**Planning & Zoning Commission Agenda**  
**Rochester Boards & Commissions - Planning & Zoning Commission**  
**May 24, 2023**  
**6:00 p.m.**

**5.A. Major Land Subdivision No. CD2023-003PLAT by Mayowood Lands, LLC, to be known as Preserve at Mayowood**

**Request:** Major Land Subdivision #CD2023-003PLAT by Mayowood Lands, LLC, to be known as Preserve at Mayowood, for the subdivision of 89.15 acres into 129 residential lots and 4 outlots.

# Agency Review Comments

PRESERVE OF MAYOWOOD  
 PRELIMINARY PLAT OVERVIEW  
 SHEET 1  
 OF 6 SHEETS

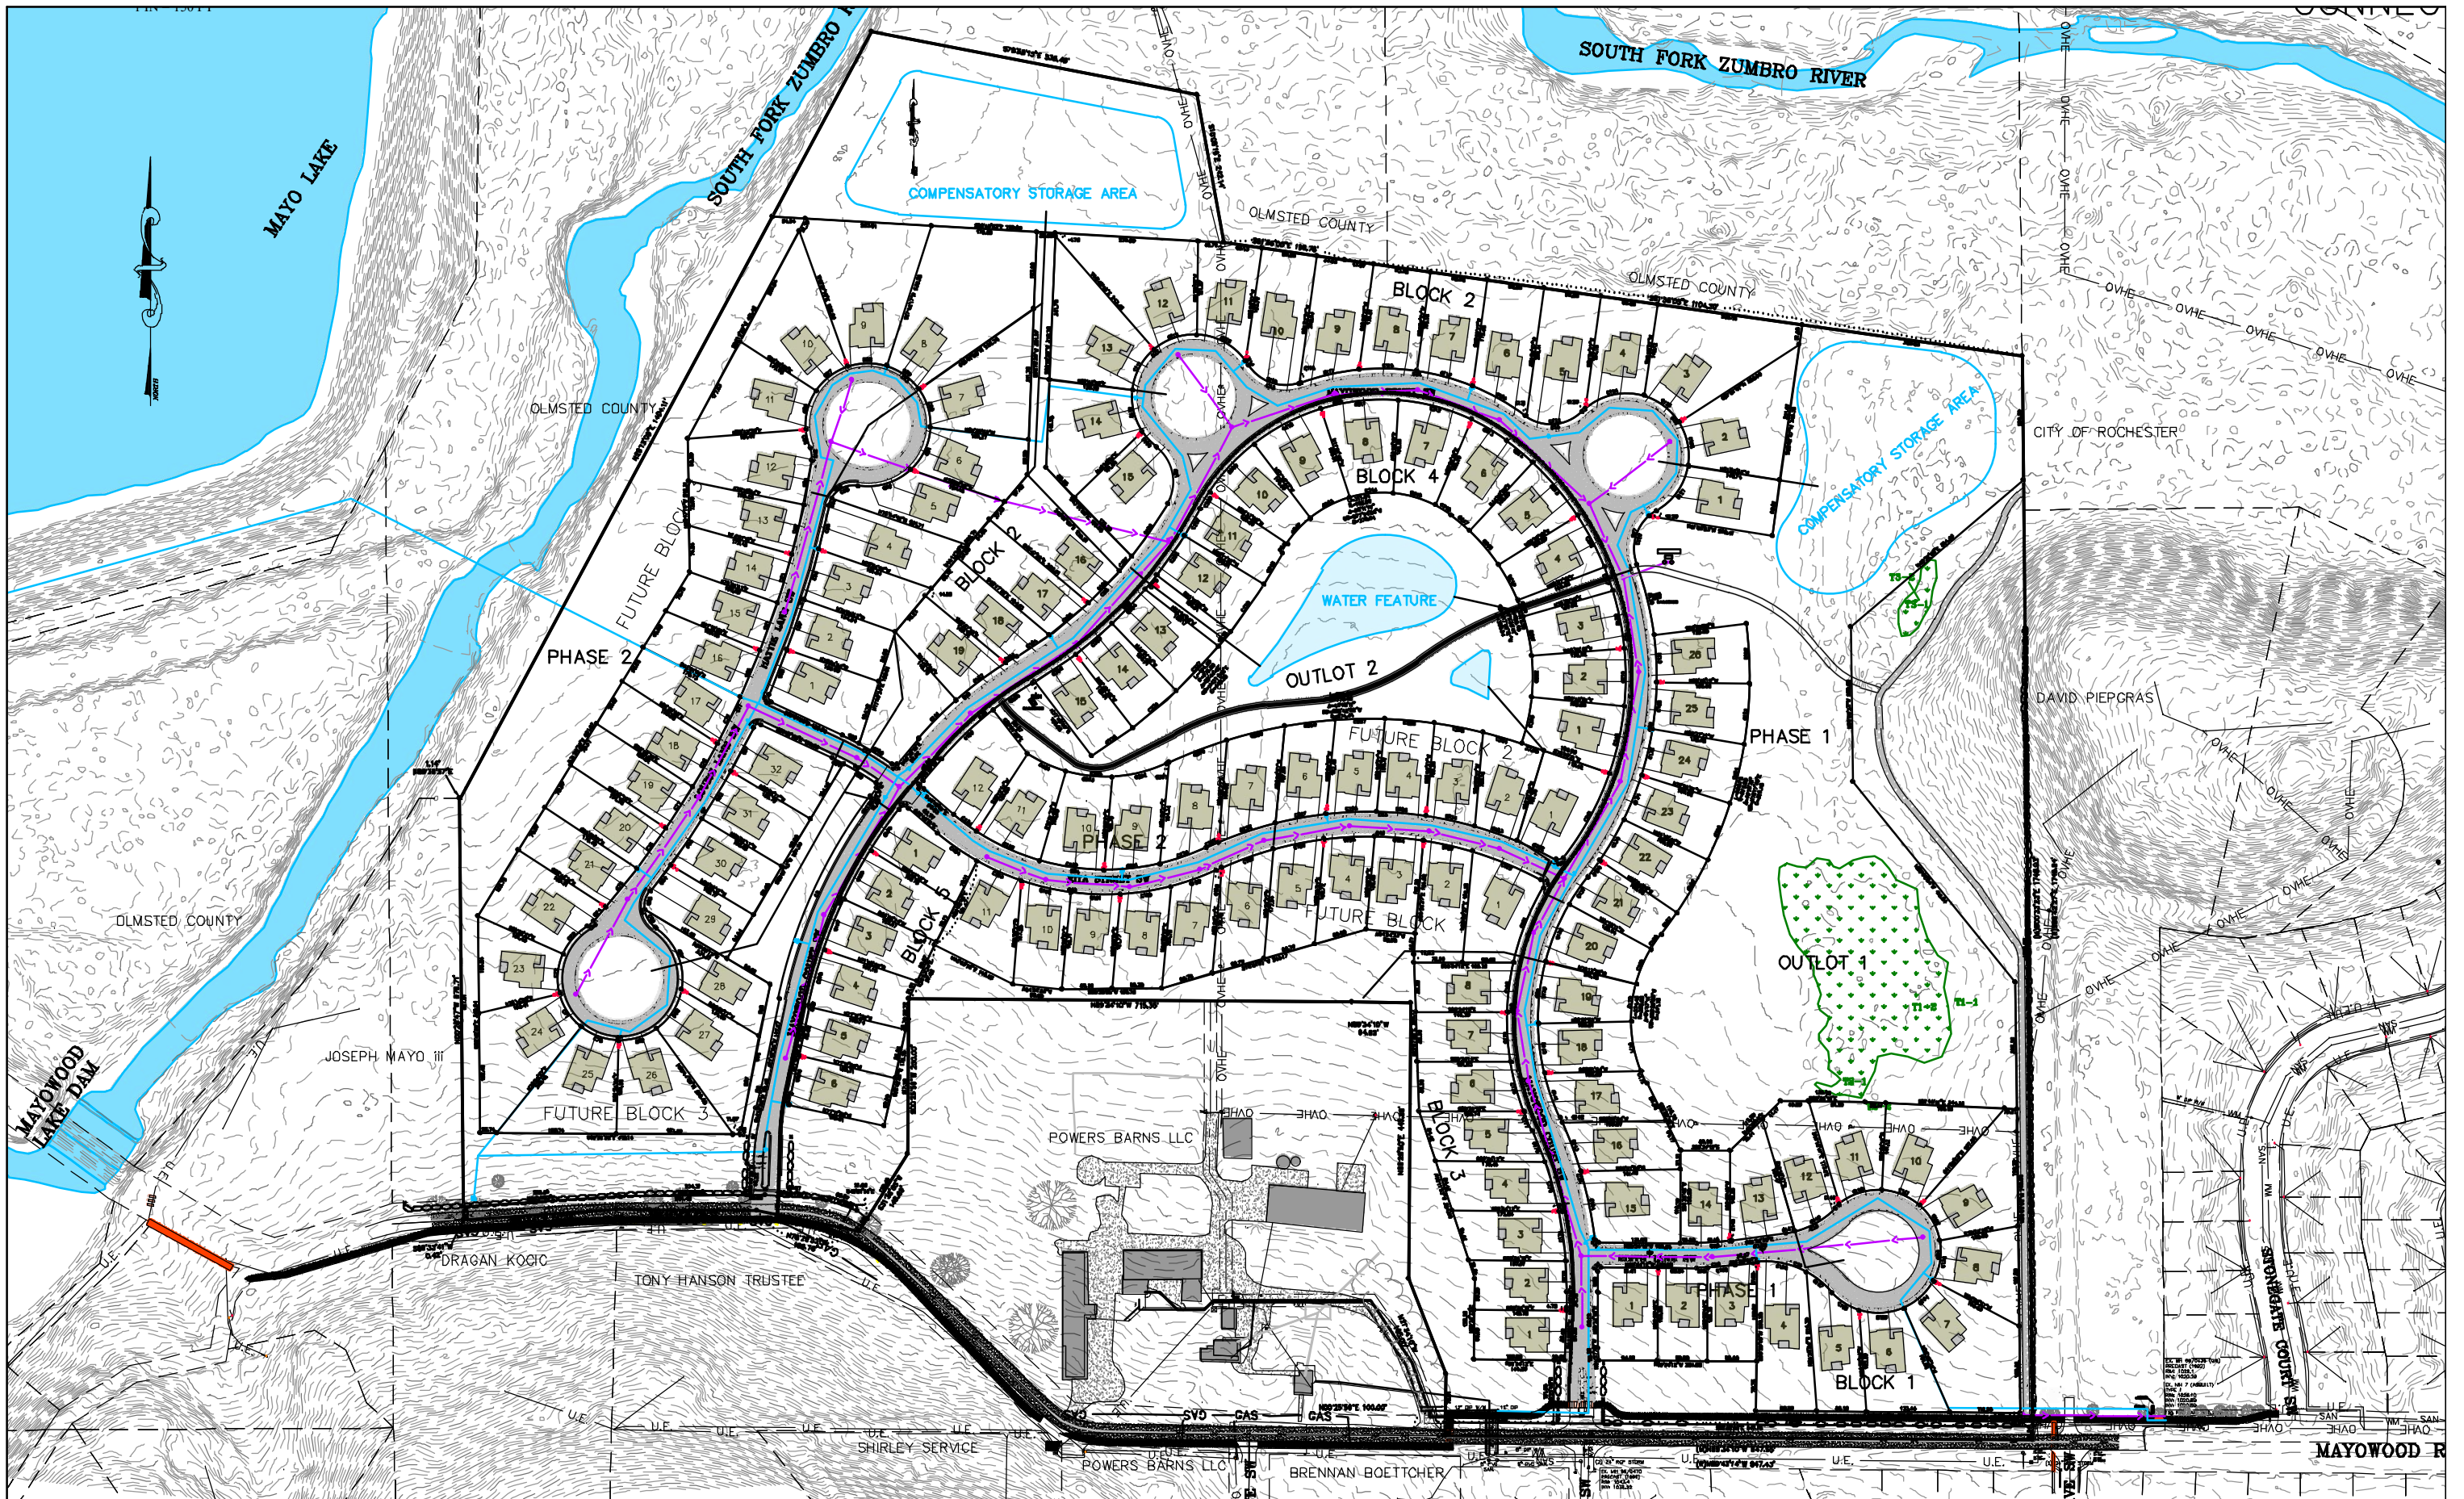
1. Prior to acceptance of a Final Plat application, the applicant shall amend the Major Land Subdivision Exhibit with the following revisions:
  - a. Site Plan Revisions to the satisfaction of RPU-Water & RPU-Electric.

- b. A pedestrian connection shall be provided on any cul-de-sac per section 60.400.040C.3F.
  - c. A pedestrian connection shall be provided on any block exceeding 600 feet in length per section 60.400.040C.3F.1.

Items to be addressed prior to application approval:

All easements shown in the attached file are required. CD2023-003PLAT - RPU Electric Comments 5-12-23

-Work with RPU on project phasing. OH line will remain in place until the new mainline is installed. Easements recorded, route to final grade, etc.

-Provide electrical load information for water feature and lift station. This information will determine final design.

1. We have uploaded to Accela a .pdf with our comments/mark-ups on the proposed water system layout.
2. Final construction plans will need to conform to the latest standard City of Rochester and MN Department of Health requirements.

3. Static water pressures within this area will range from 53 PSI to 65 PSI depending on final grades.
4. The Fire Prevention Bureau will need to comment on the location of the proposed fire hydrants.

6. A 12" water main was previously extended into the Mayowood Stone Barn property with a 20' UE dedicated for future extension to the north. This connection would provide redundant supply to the Stone Barn property and eliminating the dead end would improve circulation and water quality. If this connection is not made as part of this project, the owner/developer of the Preserve at Mayowood shall provide a letter signed by Powers Barns, LLC, the owner of the Stone Barn property, indicating their acknowledgement of the following: 1) they are aware that the water in the dead end 12" water main can become stagnant with low use; 2) they are satisfied with the current water quality; 3) they are comfortable without a redundant (two way) feed. If a letter from Powers Barns, LLC is not submitted, the proposed water system for the Preserve at Mayowood shall be revised to connect to the existing 12" water main and extend through the remainder of the Stonewood Barns Property as originally planned.

7. A 20' Water Main Utility Easement shall be provided between lots 6 and 7 of Future Block 1 to allow for looping water main in the event that there are persistent water quality issues at Mayowood Stone Barn. No water main shall be installed at this time.
